**DA-60/2014 - TWO LOT SUBDIVISION - THE  
LAKES WAY ELIZABETH BEACH**

**DEVELOPMENT CONTROL UNIT MEETING**

**Subject: PES - DA 60/2014 - Subdivision - 6 The Lakes Way Elizabeth Beach**  
**Index: DA 60/2014 & PK 9383**  
**Author: Development Assessment Planner - Steve Andrews**  
**DCU Meeting: 25 February 2016**

**DA 60/2014 Subdivision of 6 The Lakes Way Elizabeth Beach**

PROPOSED SUBDIVISION OF 6 THE LAKES WAY ELIZABETH BEACH Scale 1:250

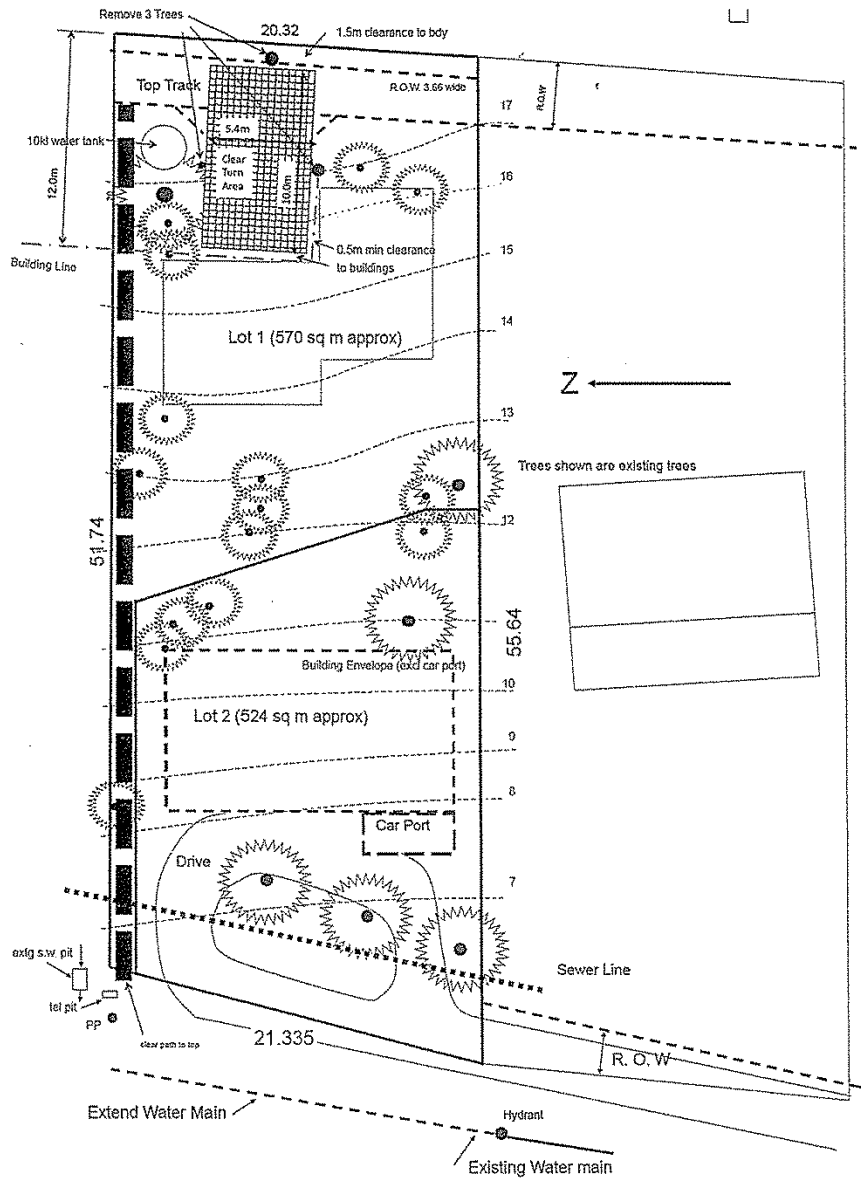
Given that the available sight distance at the right of carriageway intersection with Lakeside Crescent is significantly less than required, it is considered that this access point would have safety implications for vehicles at the location. The sight distances would also not comply with the requirements of the NSW Roads and Maritime Services. The applicant agrees that a right turn into and out of the right of carriageway is unsafe and the customary means of entry and exit is using left turn only (ref. Statement of Environmental Effects). In order to address the safety issue, it is recommended that any subdivision of the lot retain access rights along the right of access to Bellman Avenue and that this become the primary access point for the development (refer to the earlier heading Background that explains how the right of carriageway to Lakeside Crescent was created).

The recommended design outcome (based on the information submitted) can be readily achieved by increasing the battle-axe handle width to the proposed rear lot (to the specifications contained in the above table) so as to accommodate vehicular access from the existing gravel track that connects with Bellman Avenue, to the south. The applicant agrees that there are no safety issues with this access connection.

The proposed design of the battle-axe handle to proposed lot 1 should be revised as discussed under the above heading Access.

It is recommended that consideration of DA 60/2014 for the two (2) lot residential subdivision of Lot 214 DP22434, 6 The Lakes Way Elizabeth Beach be deferred with the view to the applicant revising the proposed design to enable vehicular access to the proposed lot 1 from the gravel track to the western end of the existing site that connects to Bellman Avenue, to the south. The design should include a widening of the proposed battle-axe handle, at its western end, to enable the parking of two (2) vehicles associated with the future occupants of lot 1. In conjunction with the revised subdivision design a driveway gradient design compliant with Australian Standard AS 2890.1 should be submitted demonstrating that reasonable vehicular access can be achieved to parking for both proposed lots with access to/from Bellman Avenue in a forward direction.

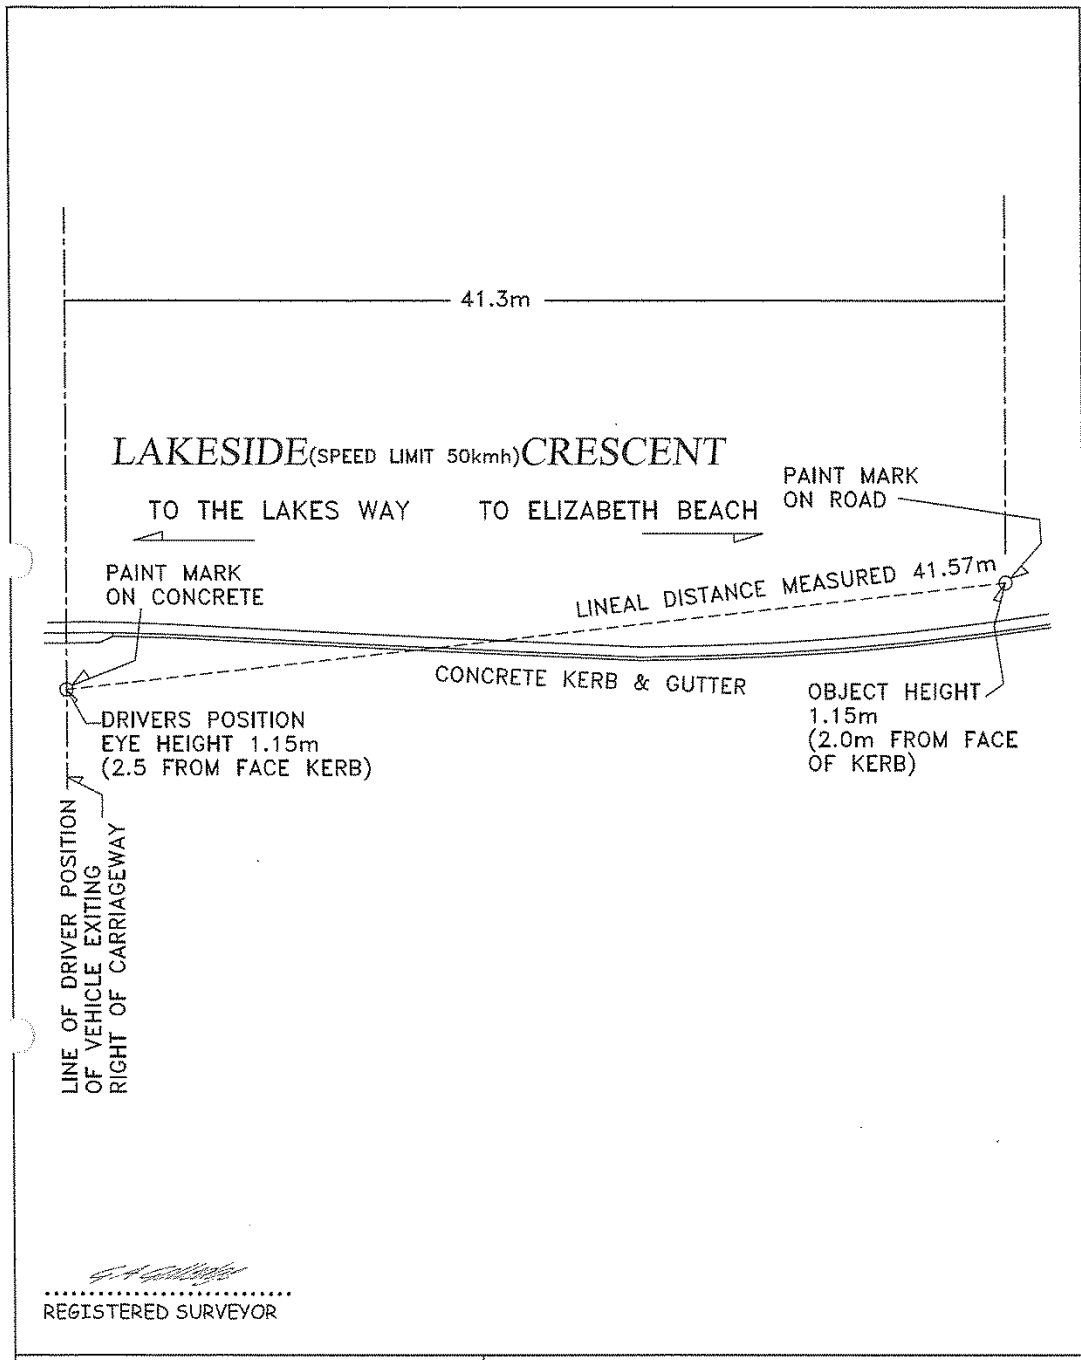
Council is required to consider whether vehicular site access to/from Lakeside Crescent is safe and complies with sight distance requirements set by NSW Roads and Maritime Services (RMS) and the relevant Australian Standards (AS2890.1). Given that the RMS has lowered the frontage speed limit to 50kph, AS2890.1 Figure 3.2 indicates that the required minimum sight distance for domestic property access is 40 metres. The applicant/owner previously submitted in his Statement of Environmental Effects that a right turn into and out of the right of carriageway (ROC) via Lakeside Crescent was unsafe and that the customary means of entry and exit was by left turn only. Therefore, left turn in and out is the alternative manoeuvre. In this regard the applicant/owner submitted a surveyor's report dated 1 July 2014, indicating compliance with AS2890.1 with minimum sight distance of 41 metres for a left turn in and out manoeuvre. The surveyor was of the opinion that parking along the southern side of Lakeside Crescent should not be permitted for a distance of 40 metres east of the ROC given the visual obstruction caused by on-street parked vehicles. The surveyor has since carried out a site assessment and concludes that the minimum sight distance is 41.57 metres (Refer to Annexure 'B').

Vision to the east at the right of carriageway (ROC) intersection with Lakeside Crescent for vehicles exiting the ROC and for vehicles travelling west along Lakeside Crescent is regularly restricted by the on-street parking of vehicles (including cars, 4WD vehicles, boats and trailers) generally associated with the adjoining Pacific Palms Resort. The vehicles are parked between the ROC entry and the driveway entrance to the resort that is located on the crest of the hill. AS 2890.1 does not take into account parked vehicles in terms of the minimum required sight distances for domestic driveways and therefore "No Parking" signage should not be implemented for access to/from domestic driveways. If such a restriction were to be imposed for domestic driveways the outcome would significantly impact on on-street parking availability adjacent to driveways in all residential areas.

Given the above information and the benefit of a site inspection by Council officers, access to/from the site utilising the ROC to Lakeside Crescent, is considered unsafe under good conditions of daylight and fine weather.

That consideration of DA 60/2014 for the two (2) lot residential subdivision of Lot 214 DP22434, 6 The Lakes Way, Elizabeth Beach be deferred for a further 60 days with the view to the applicant revising the proposed design to enable vehicular access to the proposed Lot 1 from the sealed road to the western end of the existing site that connects to Bellman Avenue, to the south. The design should include a widening of the proposed battle-axe handle, at its western end, to enable the parking of two (2) vehicles associated with the future occupants of Lot 1. In conjunction with the revised subdivision design a driveway gradient design compliant with Australian Standard AS 2890.1 should be submitted demonstrating that reasonable vehicular access can be achieved to parking for both proposed lots with access to/from Bellman Avenue in a forward direction.
